**GLADSTONE PLANNING COMMISSION AGENDA
GLADSTONE CITY HALL, 525 PORTLAND AVENUE**

2. Public Hearing: Z0312-13-D, drive-thru coffee shop on Parcel 3 of the Walgreens property, 20180 McLoughlin Blvd. The entire development received general approval through the master plan for the site, with a condition being development on the remaining two pads come back for specific design review.
3. Public Hearing: Road name proposal; Jared Colton. "Larissa Lane," new street off Tim's View Avenue to serve parcels created through planning file Z0384-11-M.

STAFF REPORT/RECOMMENDATION TO THE GLADSTONE PLANNING COMMISSION

File: Z0312-13-D
Applicant: Seven Hills Properties
Hearing Date: July 16, 2013
Planning Staff: Clay Glasgow
Report Date: July 8, 2013

Rev	Description	By	Client
	Butler Consulting, Inc.		BLACK ROCK COFFEE BAR
	16110 SE Goosehollow Drive Damascus, Oregon 97089 (503) 658-0200 (503) 658-0204 fax		McLOUGHLIN BLVD GLADSTONE, OREGON
			SITE PLAN
			Job No. 402-0531-01
			Client Zech/Waters
			Date 6/19/13
			By MEB
			Sheet A-1

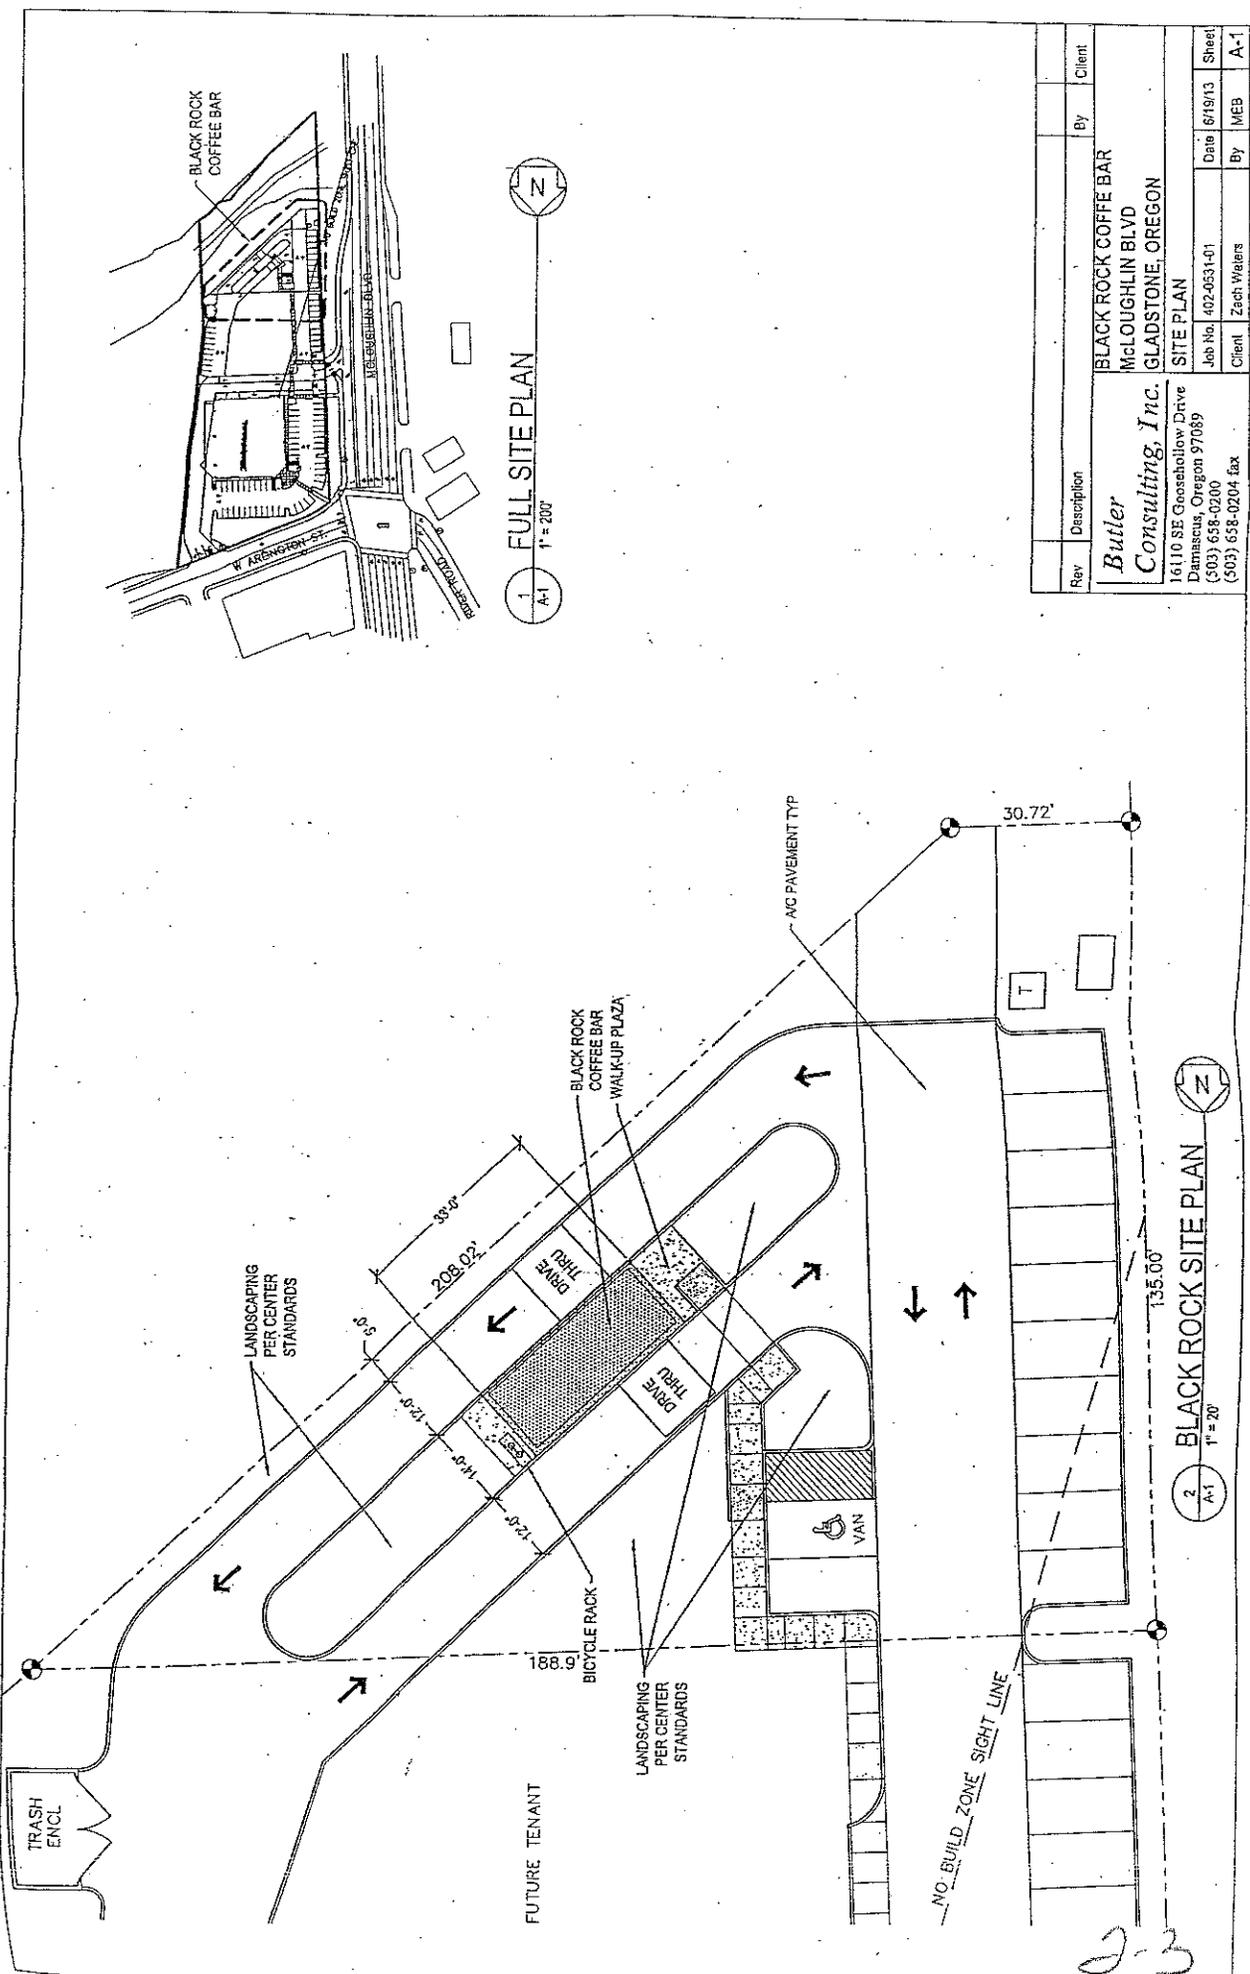
The applicant has submitted evidence that the proposed structures satisfy the window-to-wall area ratio on the façade facing McLouhglin. Aside from the drive-up windows themselves, the northerly and southerly sides of the structure are relatively devoid of windows, though other fenestration provides interest to the wall(s). This should be discussed by the Planning Commission.

Subsection 17.46.020(1) requires a minimum of fifteen percent of the lot area be landscaped. The submitted site plan shows areas to be landscaped, meeting the 15% requirement, though no detail is given. A condition of approval is warranted to require submission and approval of a landscape plan showing satisfaction of this subsection.

Section 17.48.050 establishes requirements for bicycle parking. The proposal as submitted does not show bicycle parking for the facility. This is a drive-thru for automobiles, but employees may choose to bike to work. This requirement can be met if at least one (1) bicycle parking space is provided.

7. The applicant shall submit a detailed landscape plan to show compliance with Subsection 17.46 of the GMC.
8. The landscaped area shall be provided with an automatic irrigation system.

9. Landscaping shall be continuously maintained. Landscape maintenance shall be the responsibility of the owner.
10. The applicant shall submit a bicycle parking plan to staff for approval demonstrating compliance with the provisions of Subsection 17.48.050.
